TEXAS COMMISSION ON ENVIRONMENTAL QUALITY

Re: Edwards Aquifer, Comal County
NAME OF PROJECT: Cibolo Creek Community Church; Located at 30395 Ralph Fair Road;
Fair Oaks Ranch, Texas
TYPE OF PLAN: Request for Modification of a Water Pollution Abatement Plan (WPAP); 30
Texas Administrative Code (TAC) Chapter 213 Edwards Aquifer
Edwards Aquifer Protection Program ID No. 1704.02; Investigation No. 654295; Regulated
Entity No. RN102748167

MODIFICATION OF A WATER POLLUTION ABATEMENT PLAN

**CIBOLO CREEK CHURCH
CITY OF SAN ANTONIO
COMAL COUNTY, TEXAS
FEBRUARY 2008
(REVISED APRIL 9, 2008)**

CIBOLO CREEK CHURCH DEPTH GAGE DETAIL

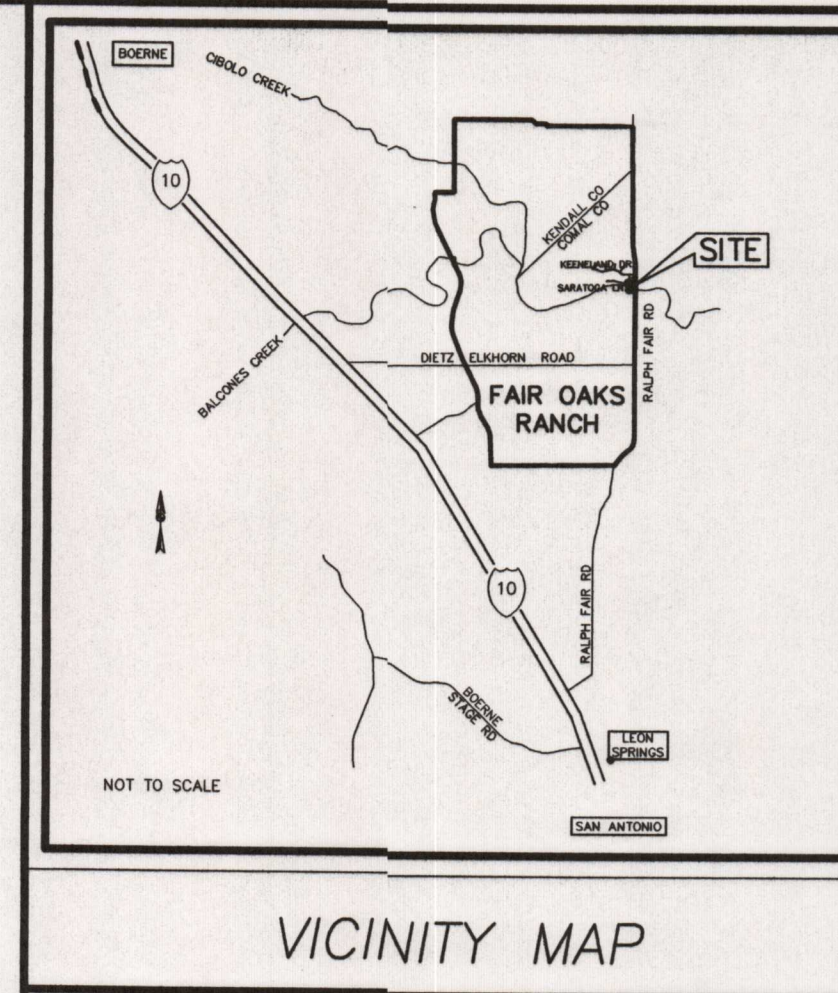
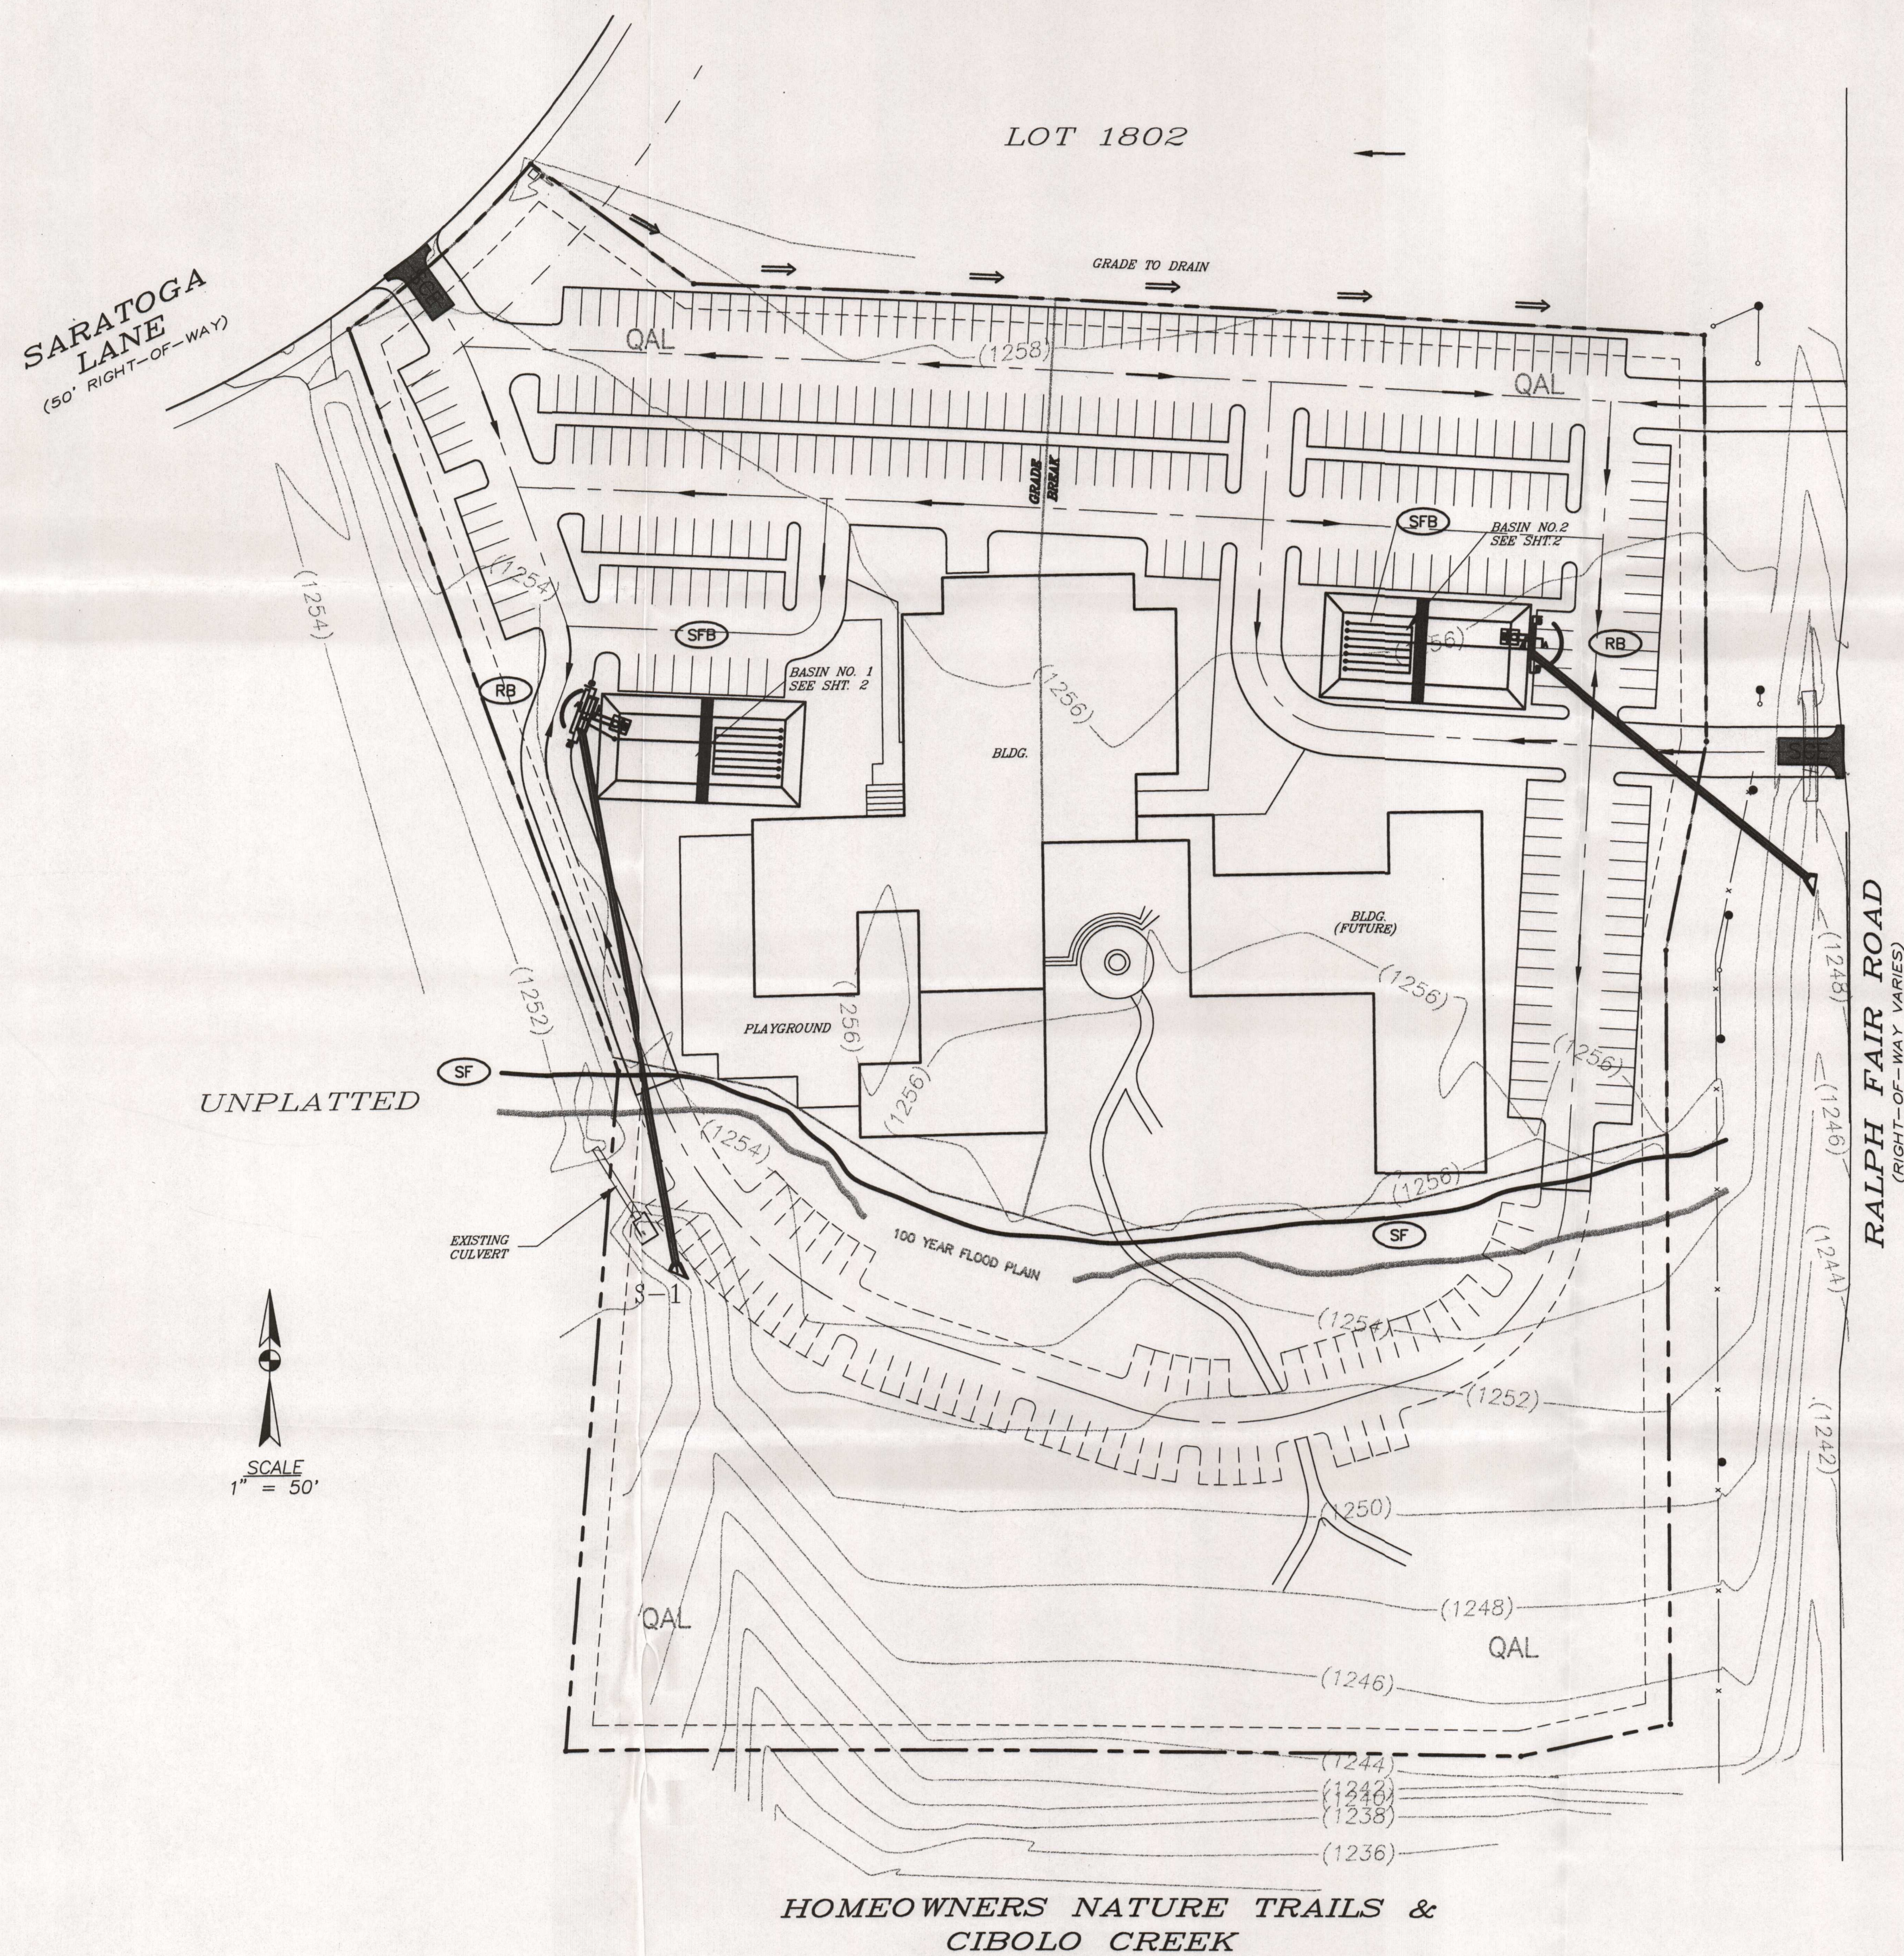
It is also proposed to add sedimentation depth gage maker , filtration drain shut off valves and replace the sand in both basins.
